Access Compliance Report Public Rights-of-Way (Curb Ramps)

Intersection ID: 49559	Main Street: SPENCER_ST	Cross Street: NODA_BV	Location: NW
ADA ID: A6F91F5D0201	Ramp Type: BlendTrans2	Initial Pass/Fail: Pass	Overall Compliance: No Severity Score: 10

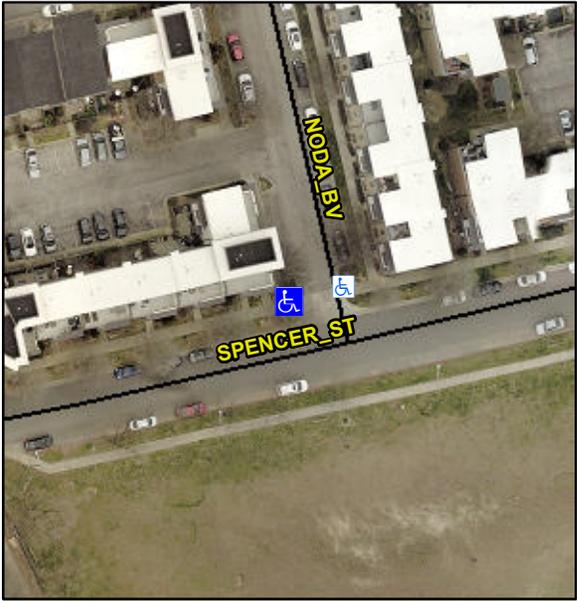
Possible Solutions:
Install Detectable Warning System.

PROW/ADA:
R305
